**ADDENDUM NO. 03 – PORTAGE PUBLIC SCHOOLS – CENTRAL ELEMENTARY SCHOOL BP 4:
CONSTRUCTION**

ADDENDUM NO. 3 (BP4)

DATE OF ISSUANCE:	June 19, 2023
PROJECT:	Central Elementary School Bid Package 4: Construction 8422 South Westnedge Avenue Portage, MI 49002
OWNER:	Portage Public Schools
ARCHITECT'S PROJECT NO.:	21-237.10
ORIGINAL BID ISSUE DATE:	May 17, 2023

SHEET NUMBER
 S 500
 21-237.10

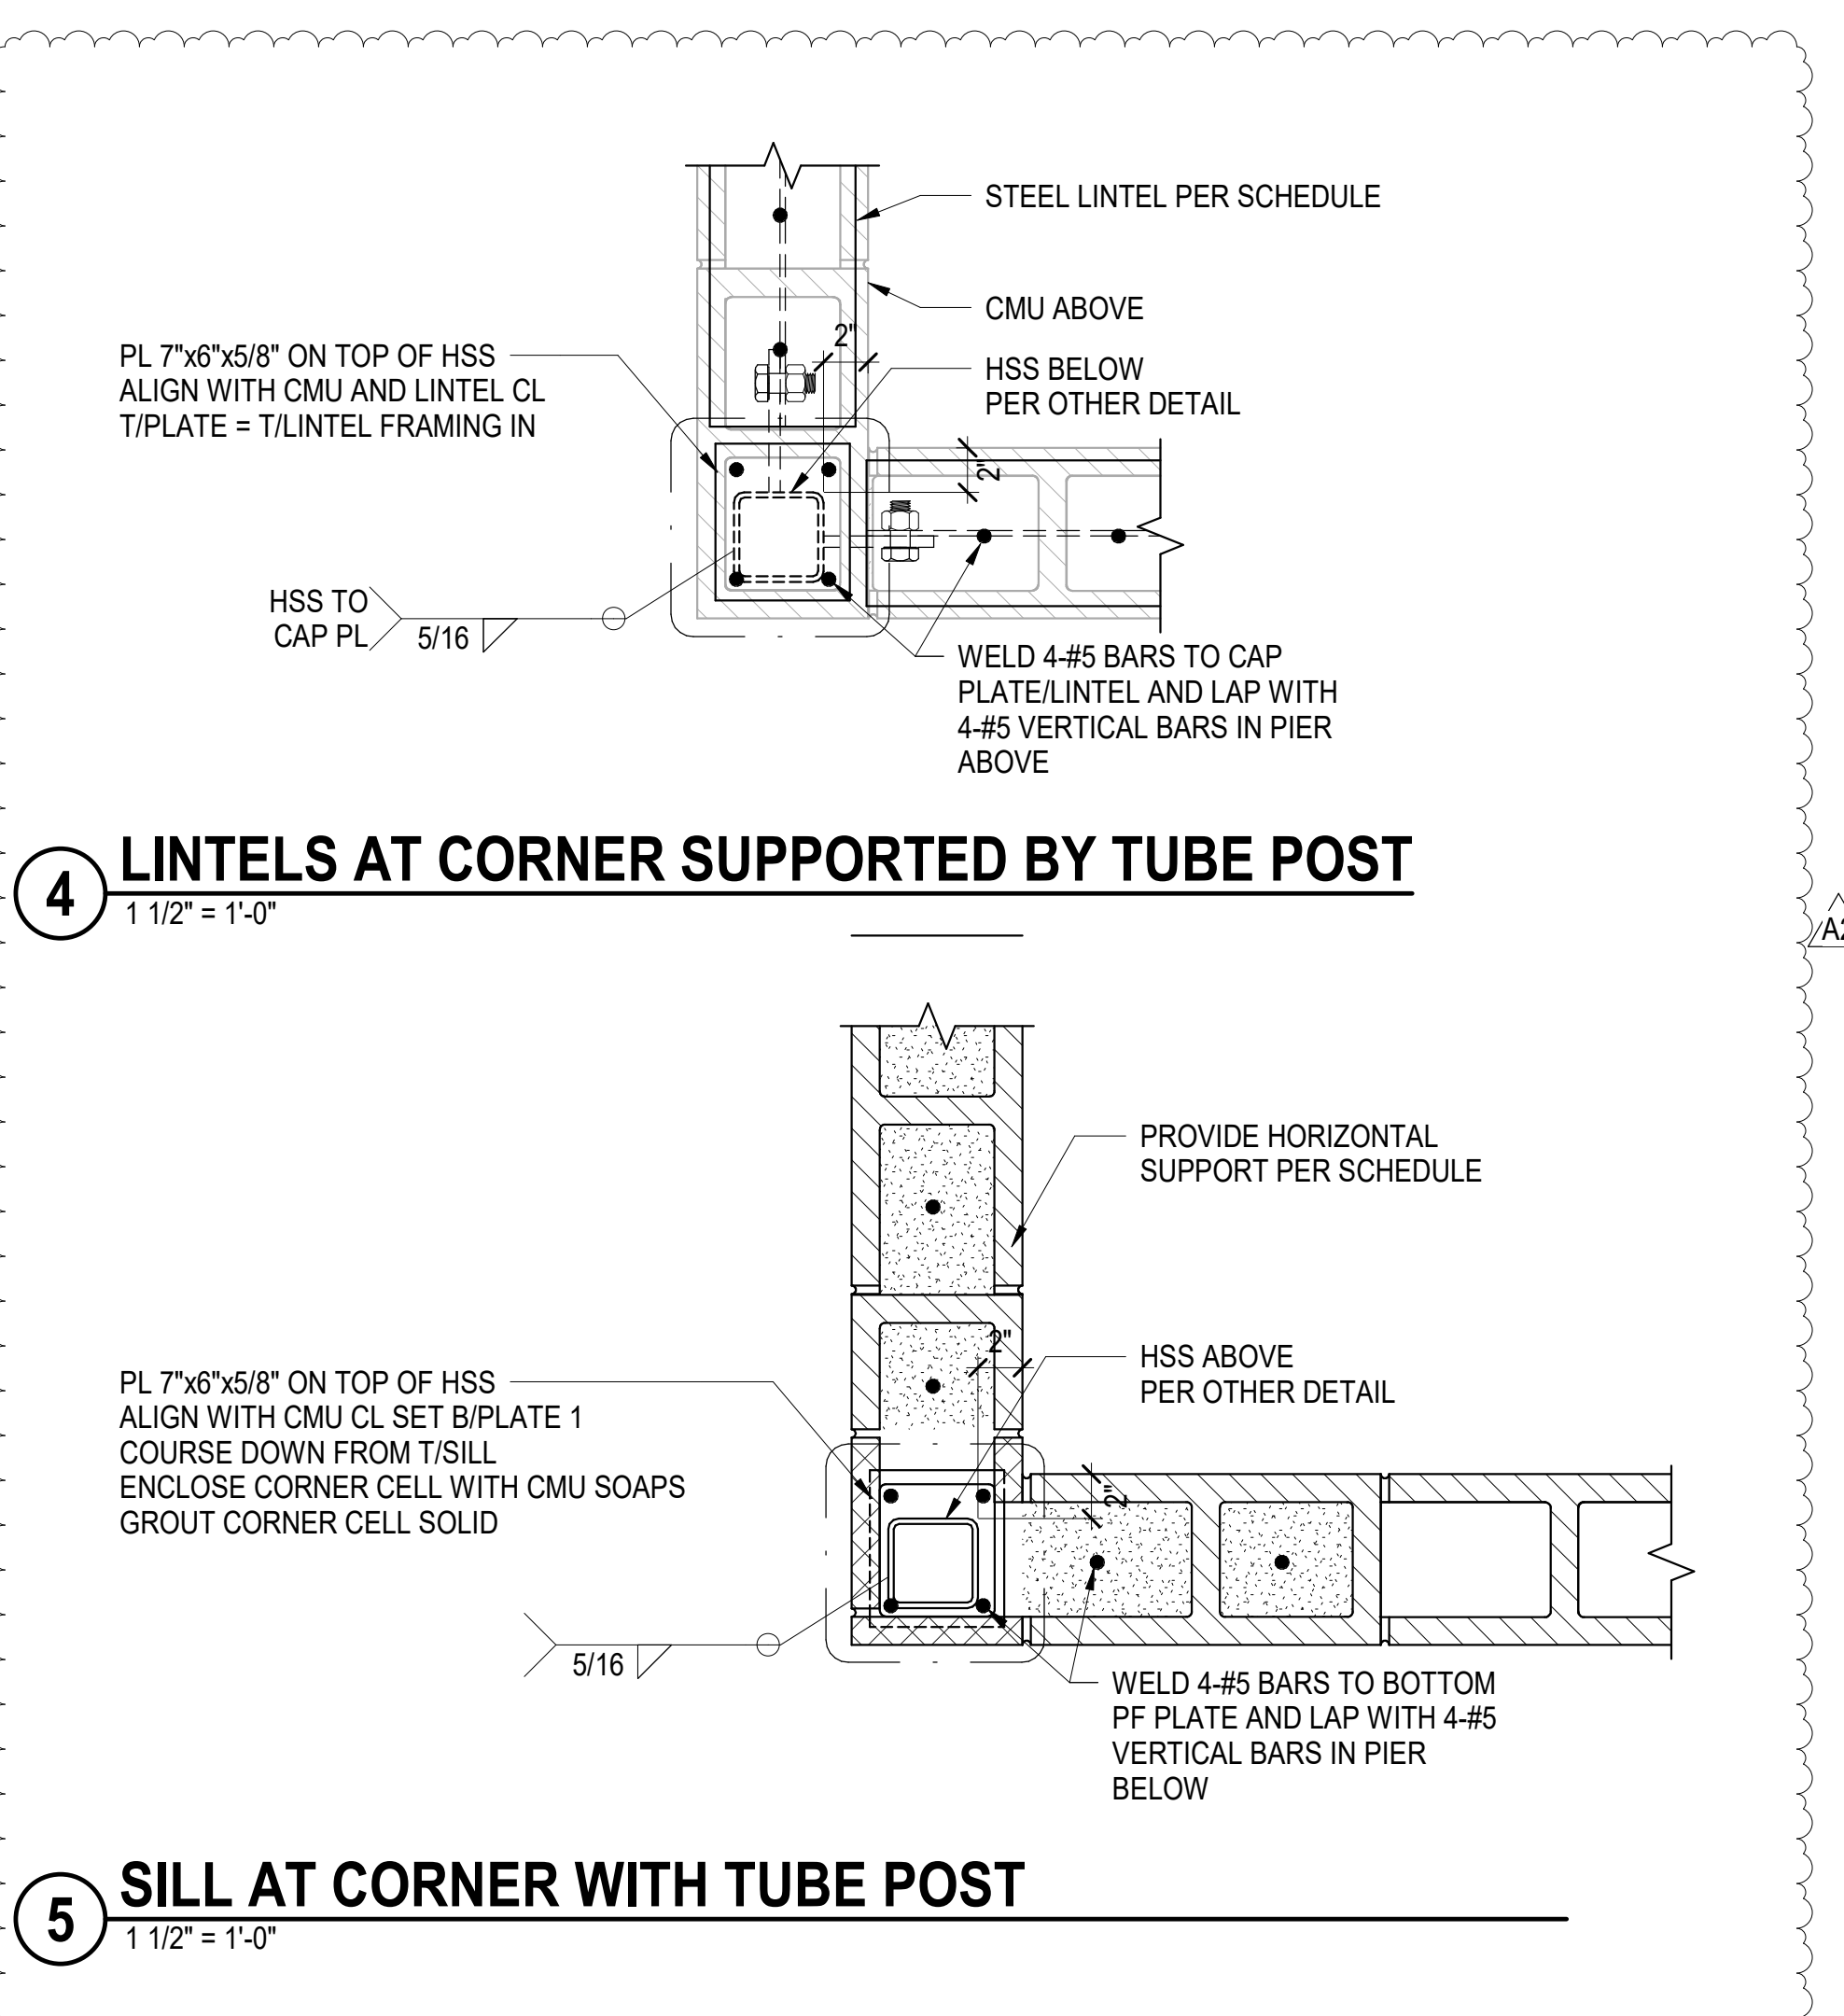
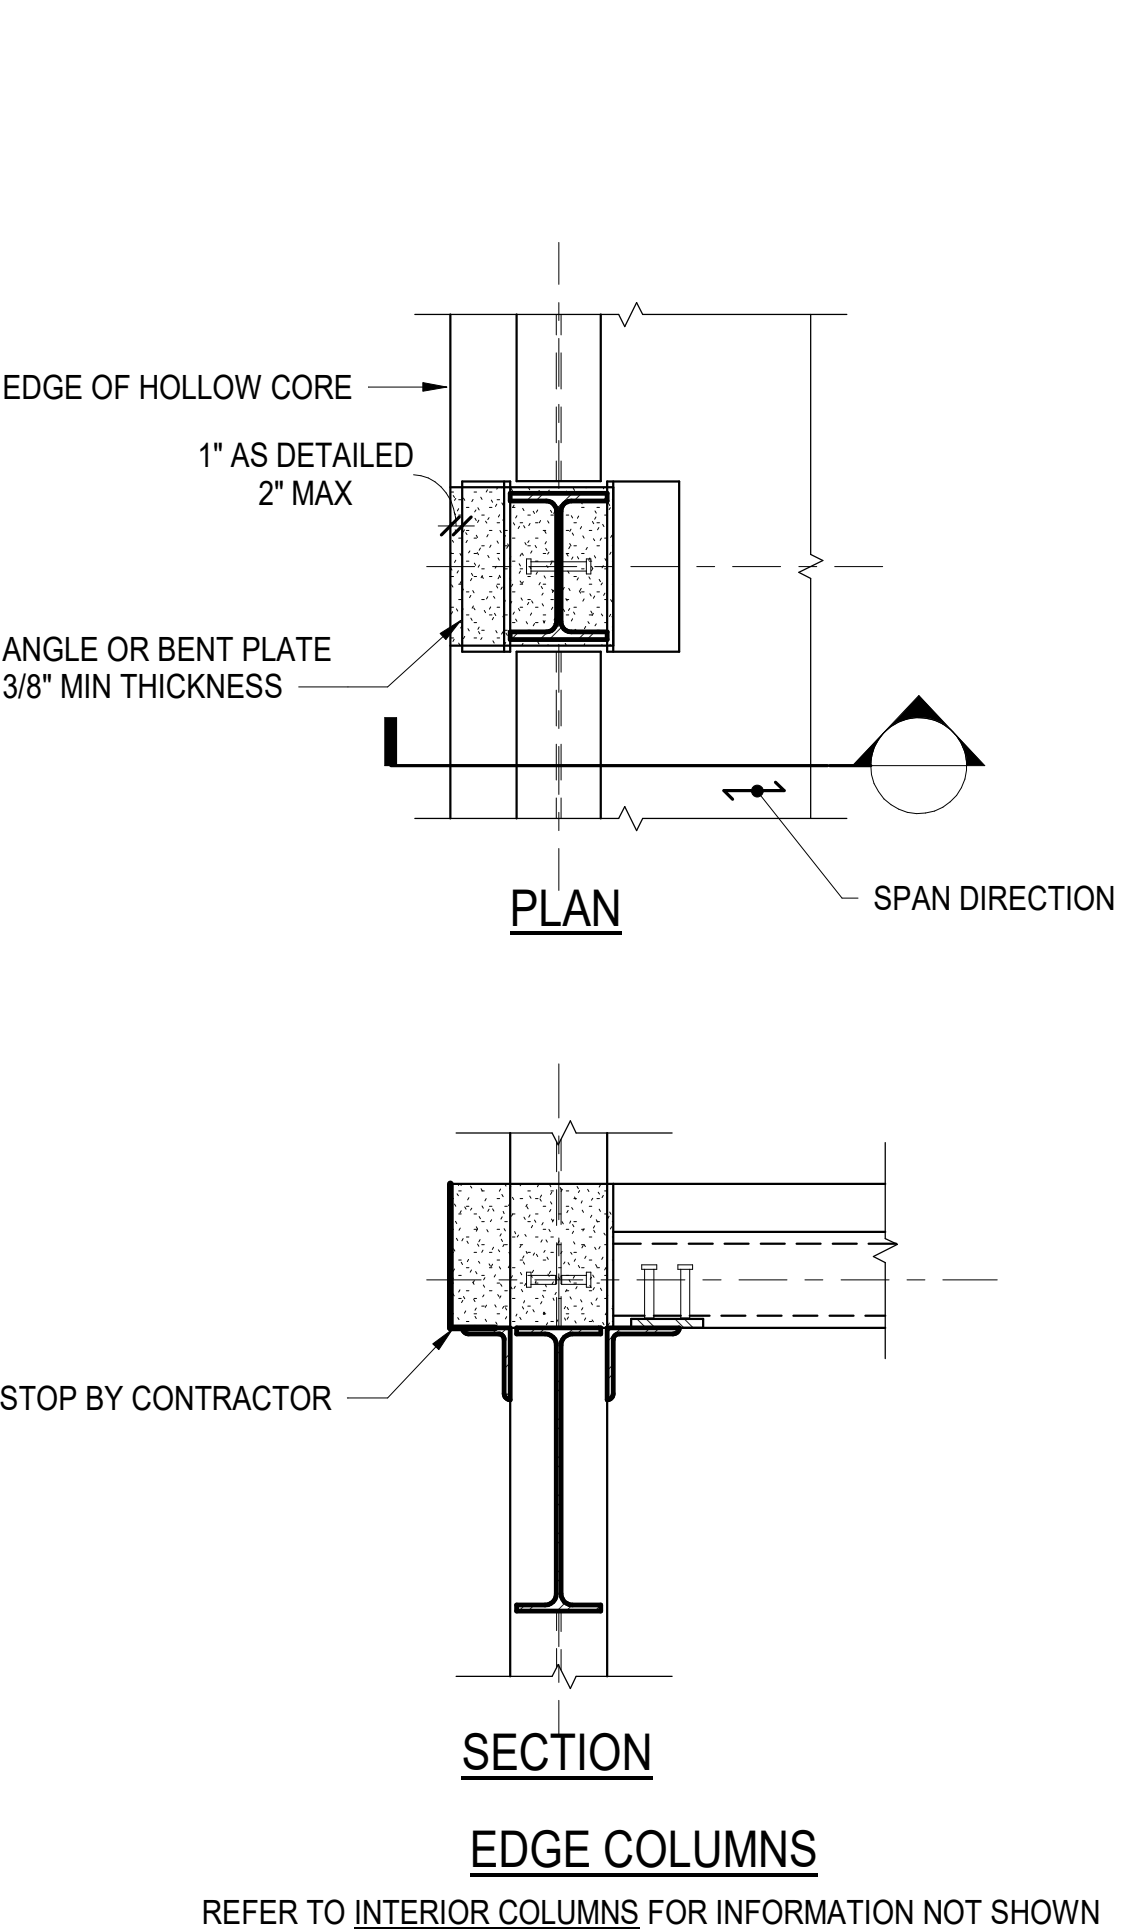
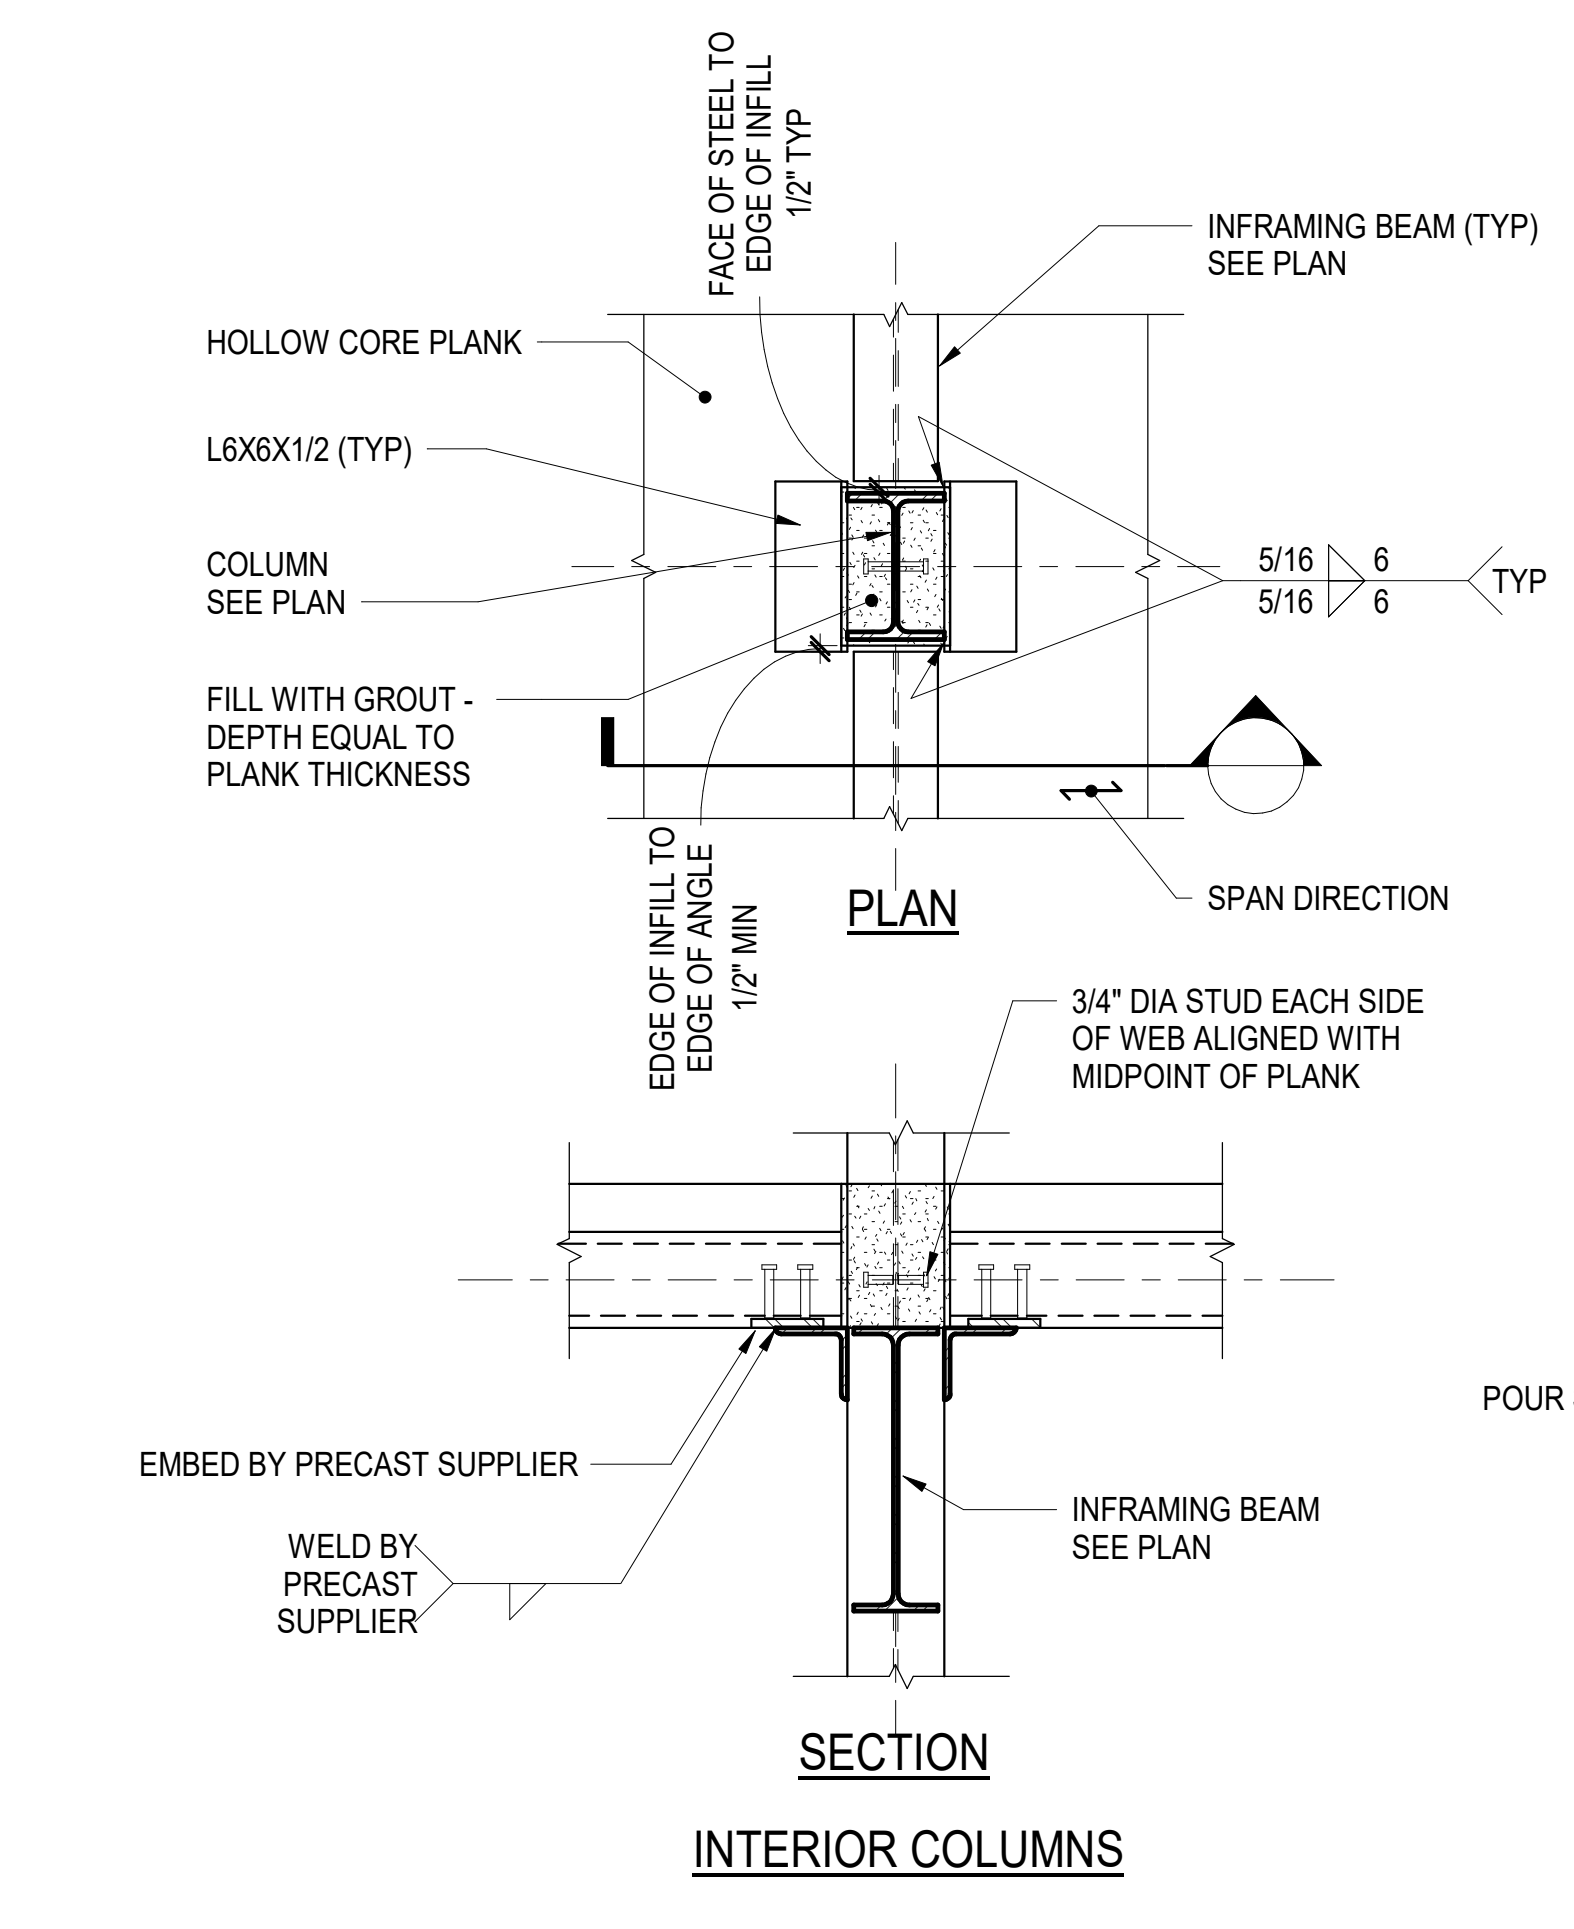
ADD-3 Item No. D-2 - P3 Reinforcing Requirements

Refer to Sheet(s): S-500, S-601

Reinforcement requirements of pier P3 revised per constructability comments. Callout referencing detail location added to S-601.

4 WALL LINTEL DETAIL AND SCHEDULE
 1" = 1'-0"

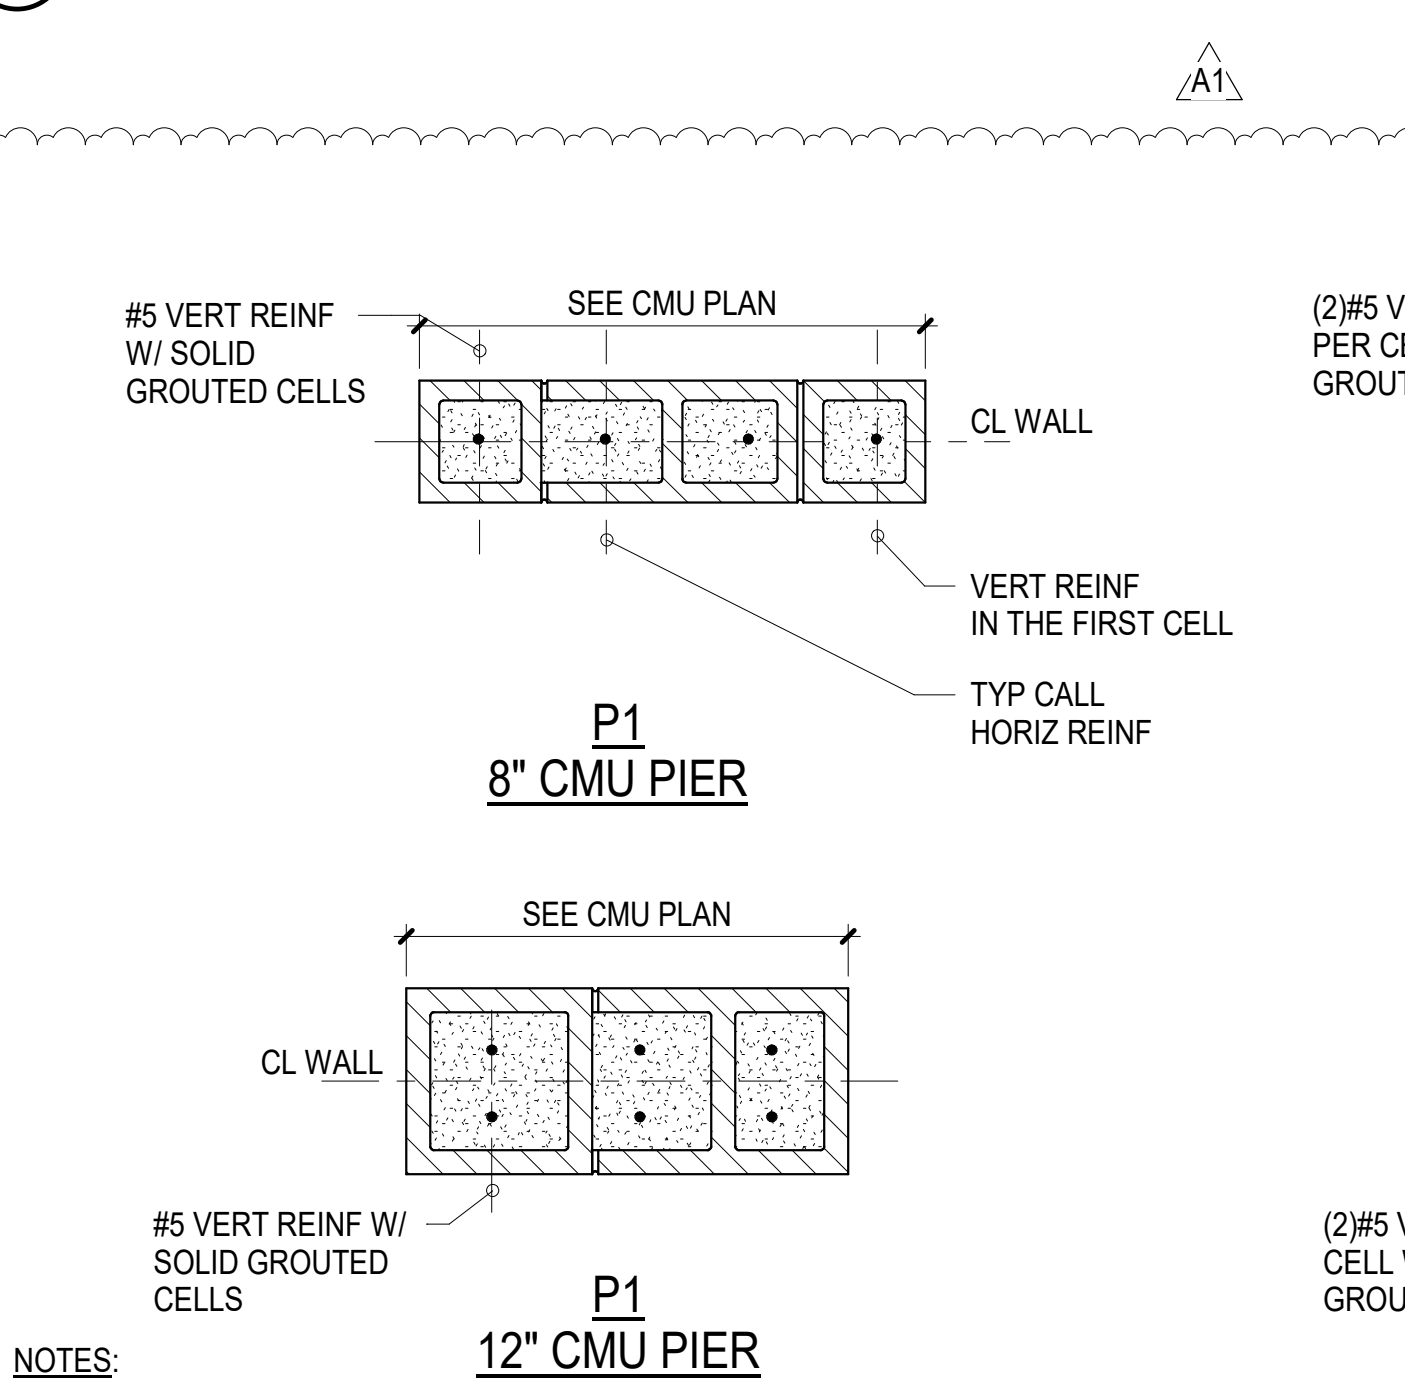
ADD-3 Item No. D-4 - Masonry Lintel Shear Reinforcement Requirements

Shear stirrups eliminated from lintels $\leq 4'-0"$ per constructability comments.
